From: Bell, Jeff
Sent: Thursday, 25 May 2017 9:30 AM
To: Hicks, Katherine
Subject: FW: 150752 Kambah Village - Meeting minutes [SEC=UNCLASSIFIED]
Attachments: C 150752 DA Drawings.zip

From: [REDACTED]
Sent: Wednesday, 1 March 2017 2:01 PM
To: Bell, Jeff; Sweet, Carma
Cc: [REDACTED]
Subject: 150752 Kambah Village - Meeting minutes

Meeting to discuss Kambah Village 19 January 2017

From: [REDACTED] <[REDACTED]@CanberraTownPlanning.com.au>
Sent: Tuesday, 3 October 2017 3:45 PM
To: Hicks, Katherine
Cc: [REDACTED]
Subject: Kambah Direct Sale Advice,
Attachments: 16072016 DIRECTSALEKAMBAH-EDD V4.pdf

Attachment 1
10.5m Truck Turning Demonstration
Plan

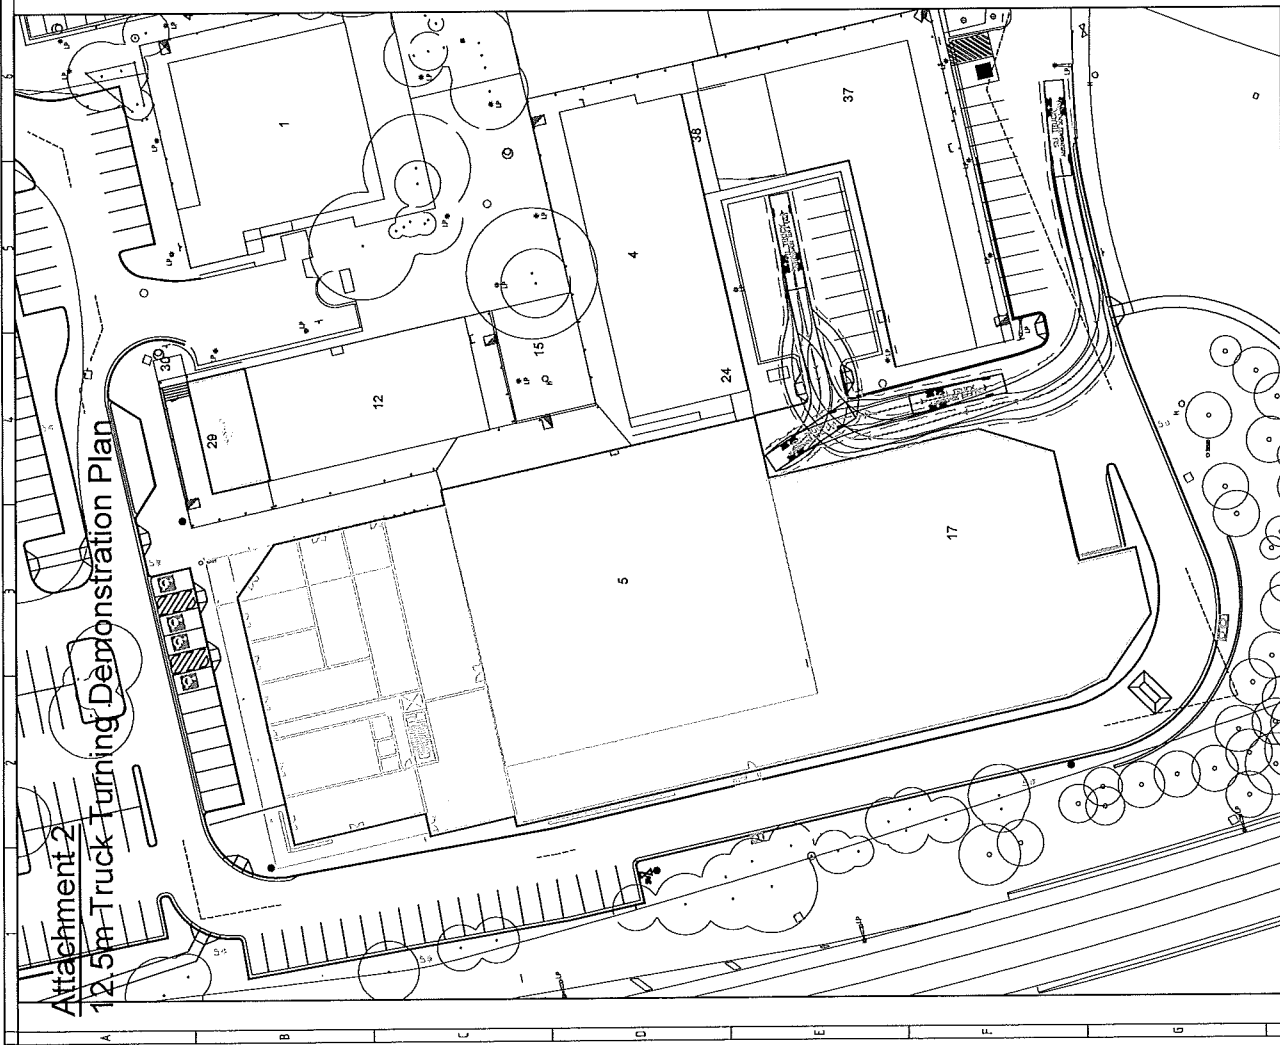
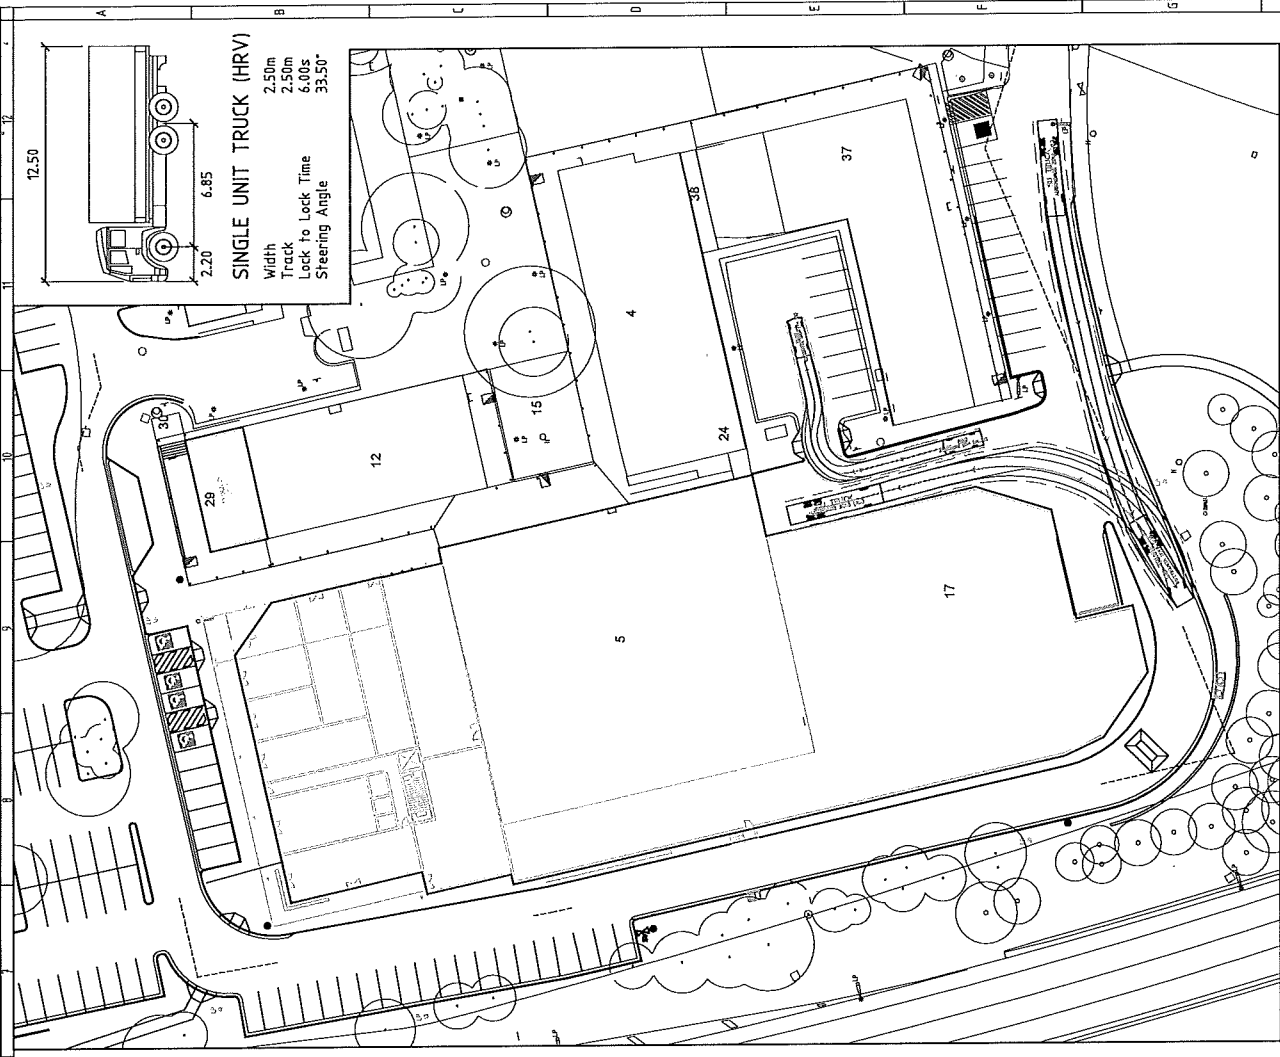
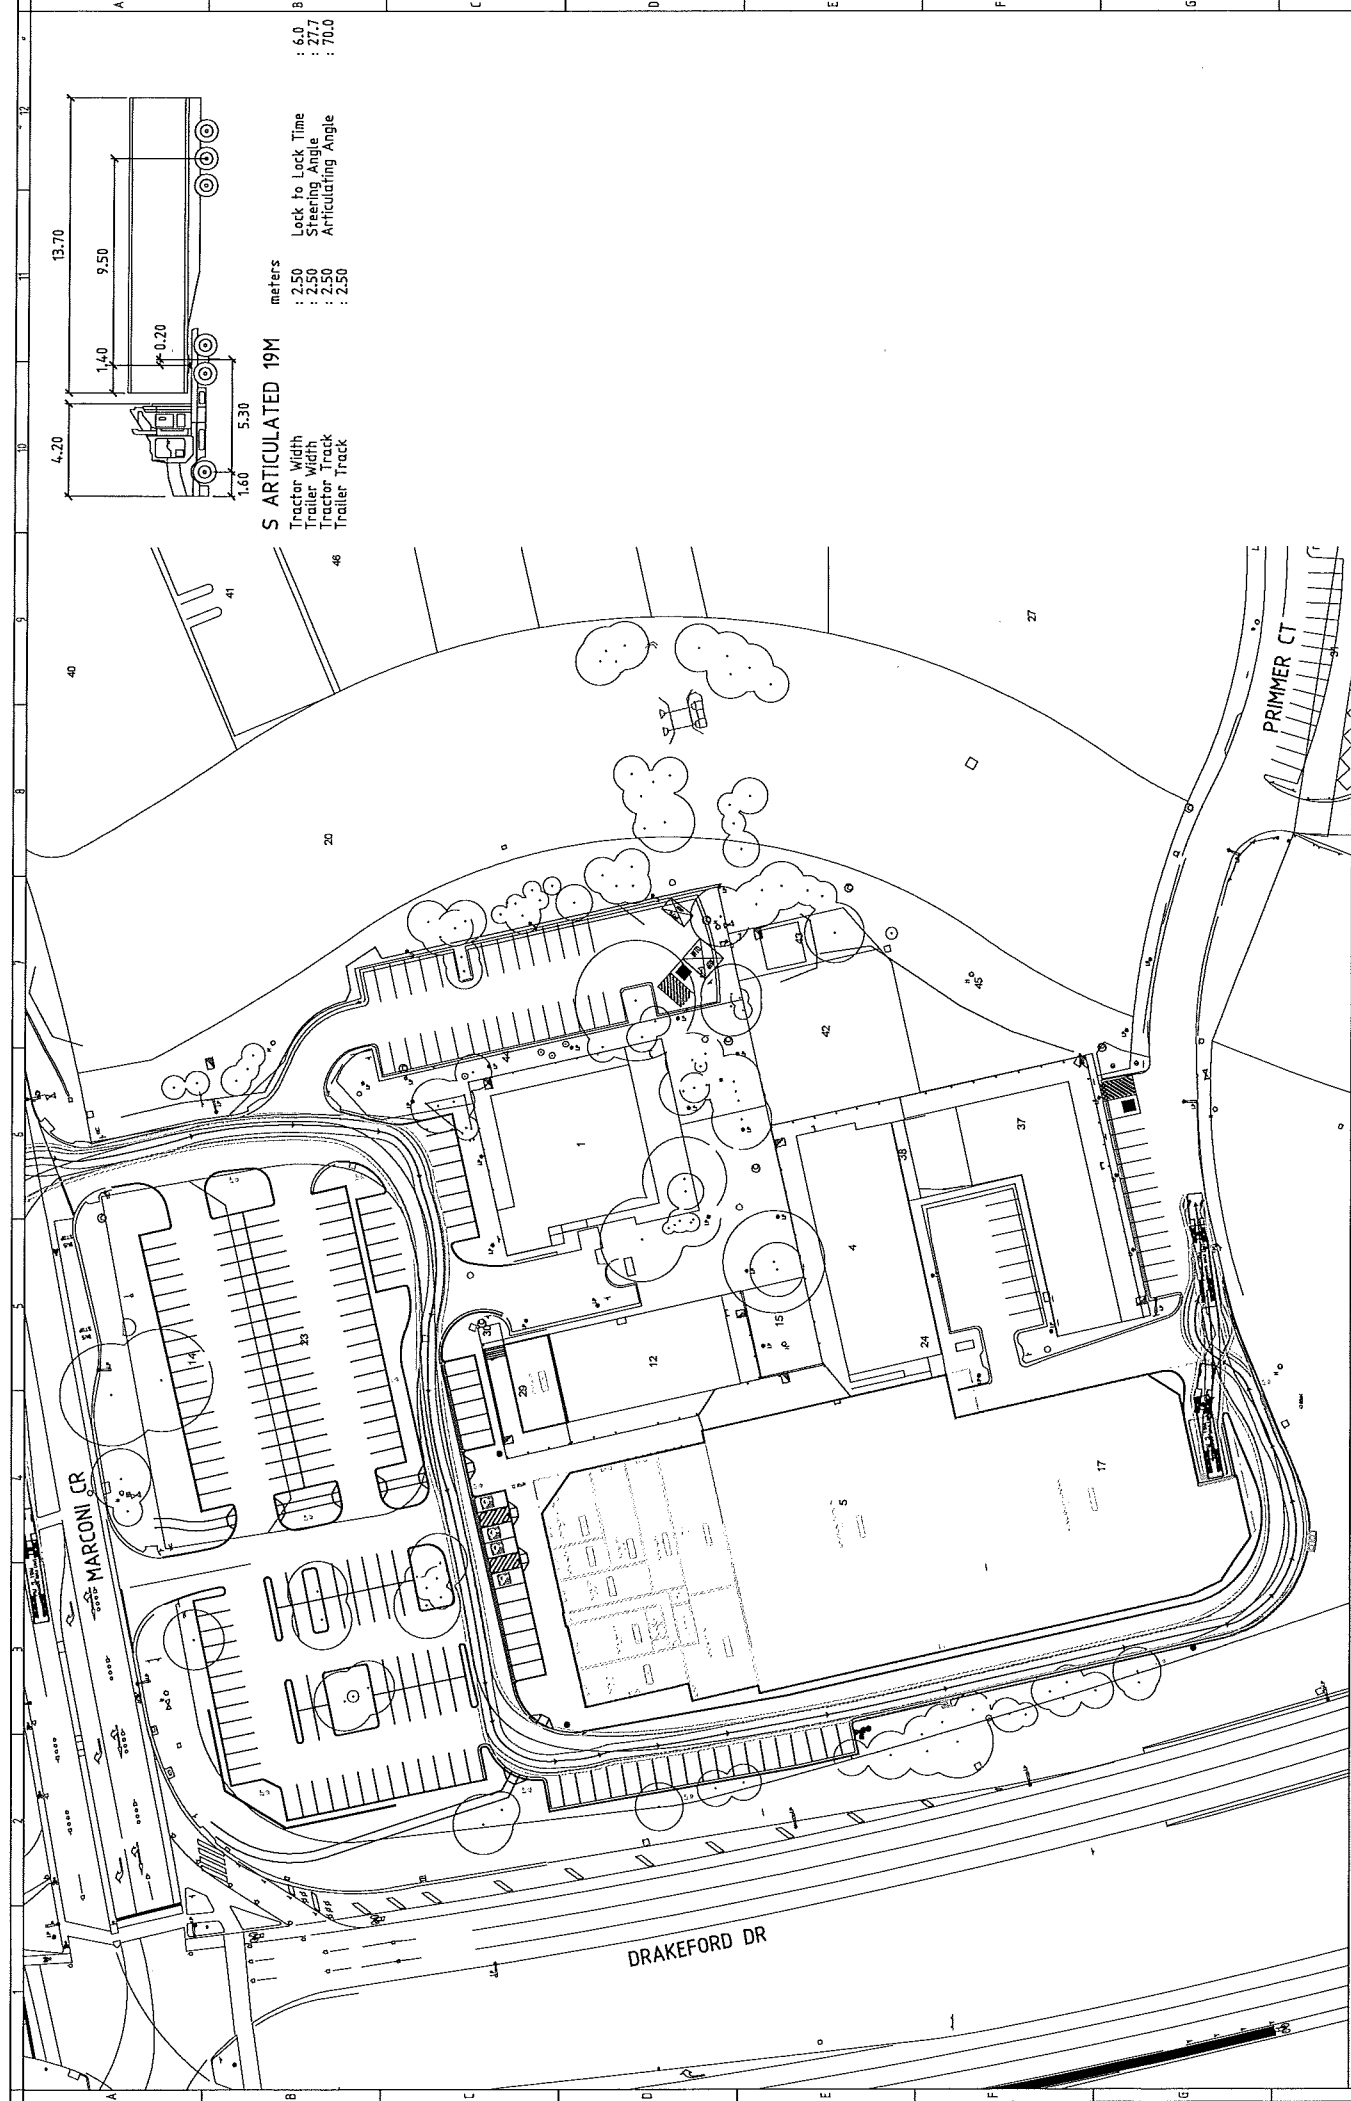
Further to our assessment and recent discussions, we provide you with the Truck Turning Demonstration Plans prepared by Sellick Consultants (included with this letter) which indicate vehicle movement paths for two different truck types that currently access the carpark and the proposed new loading zone areas:

We have confirmed the opportunity for a 10.5m truck to enter carpark without impacting on the existing carpark, however some minor alteration of pedestrian pram crossings is proposed to facilitate access for a 10.5m delivery truck. The works can be completed as part of the supermarket development, will not impact on the operations of the carpark or a trucks' ability to service the waste collection point by the 10.5m waste truck and will not alter the amenity of this space in any significant manner. This scenario preserves the current waste collection situation as well as servicing of business by rigid trucks up to 10.5m in length.

Attachment B

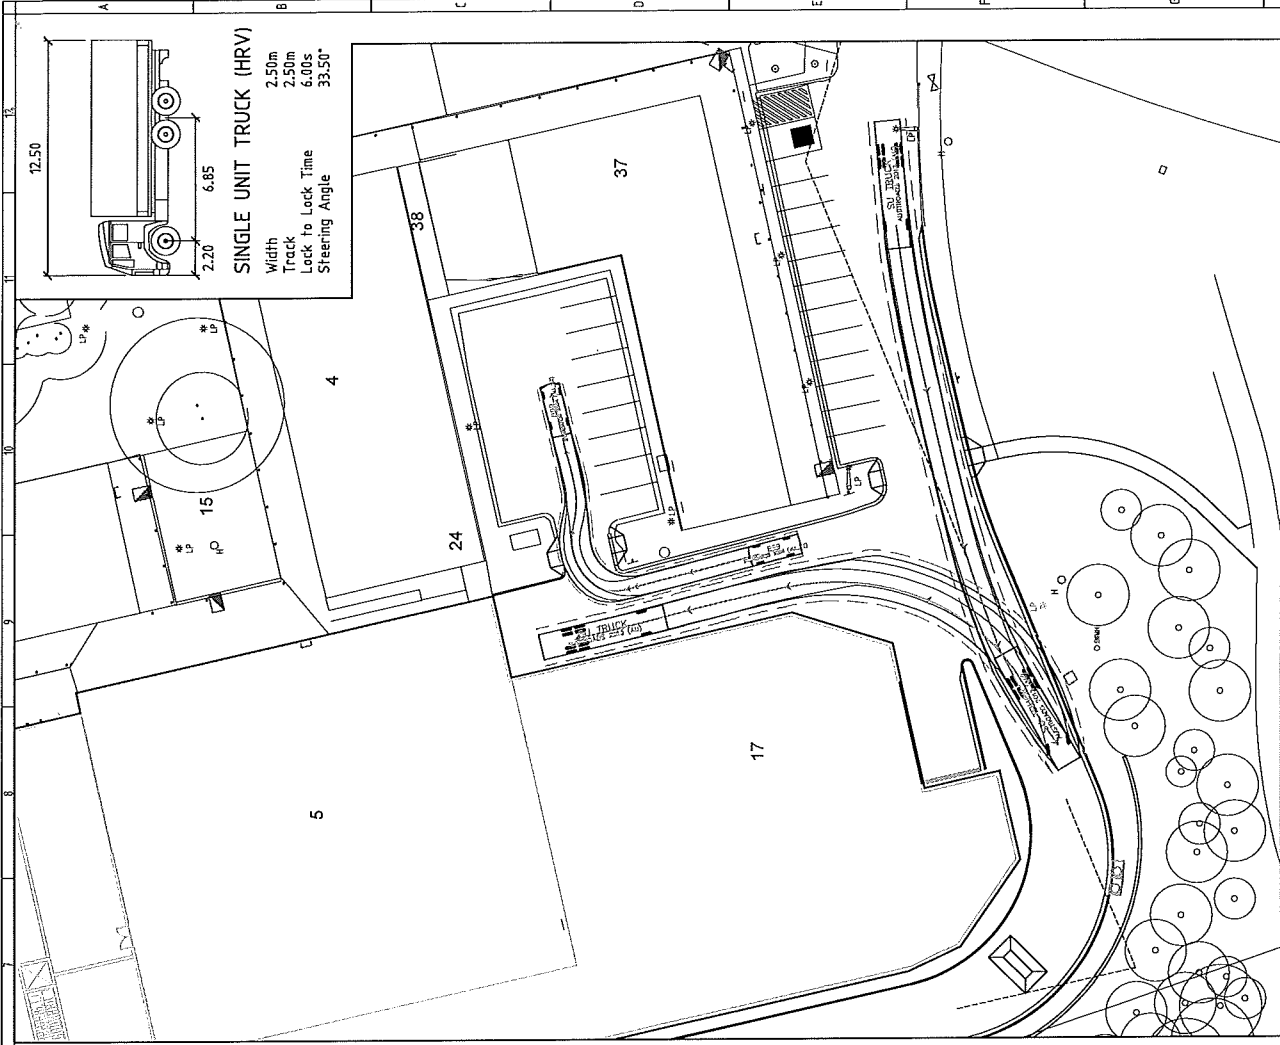
This scenario is considered an improvement on the current arrangement that sees the 12.5m trucks reversing into the carpark and blocking entry and vehicle movements whilst loading operations are being conducted. In the proposed scenario (with the creation of the loading dock), the 12.5m truck can be parked for loading while enabling a vehicle to enter/exit the carpark with minimal to no interference.

Attachment B - Drawing C 150752 DA-C505 Turning Demonstration Plan 5 (A) detailing 10.5m and 12.5m truck access arrangements proposed for consideration towards Development Application

Attachment C

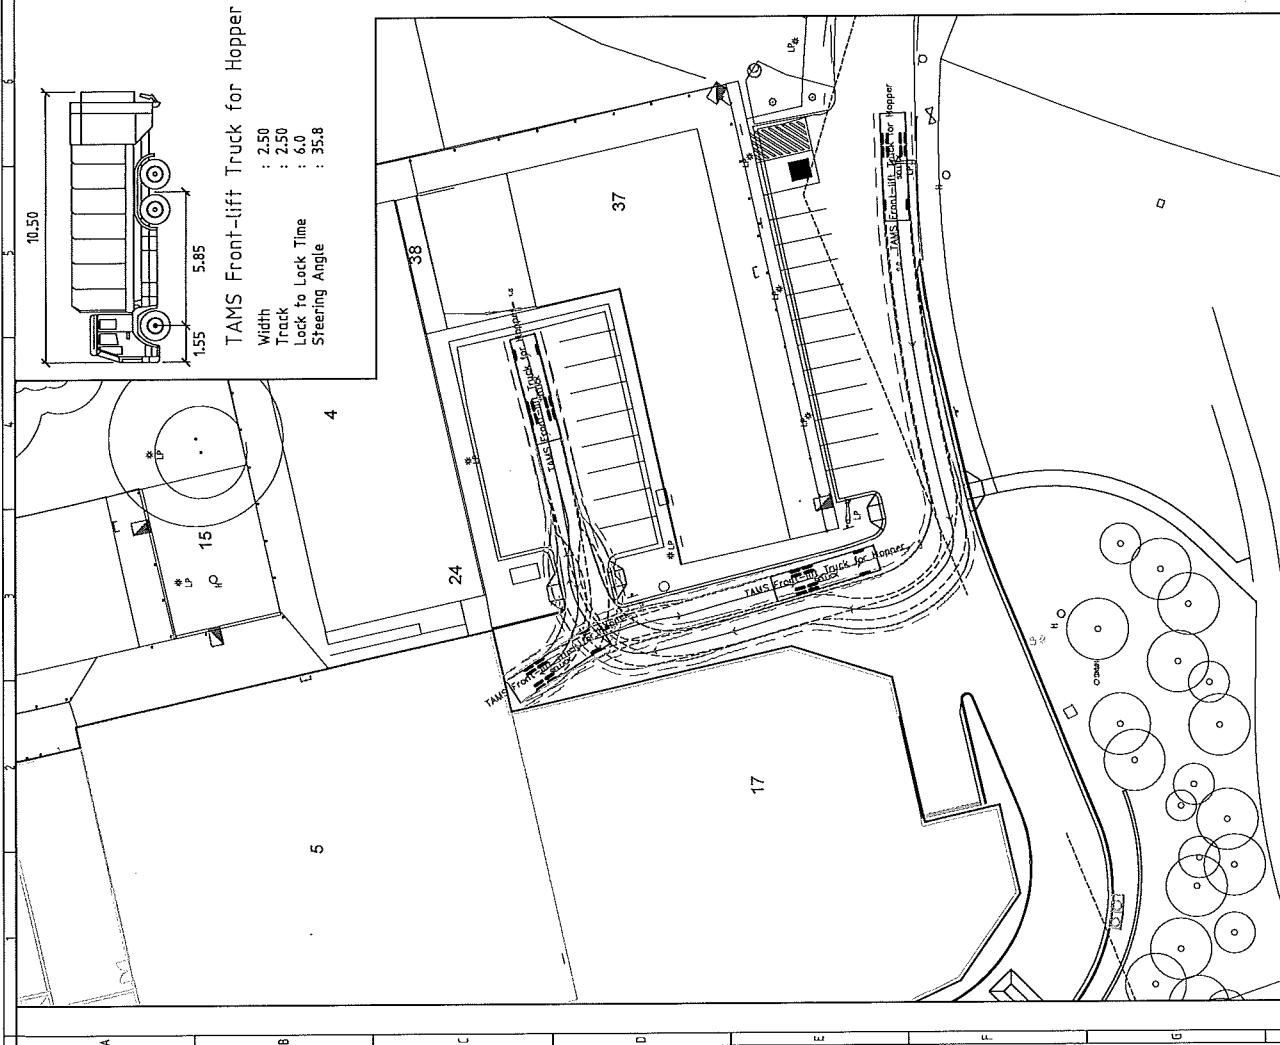
The subsequent swept path analysis, provided by the design consultant has indicated that access from Kett Street is not practical without reconfiguring the loading bay. Based on the information provided to date, TCCS cannot support the proposed service vehicle arrangement for the supermarket.

Attachment C - Drawing C 150752 DA-C501 Turning Demonstration Plan 1 (A) Detailing Semi-Trailer access to the proposed supermarket
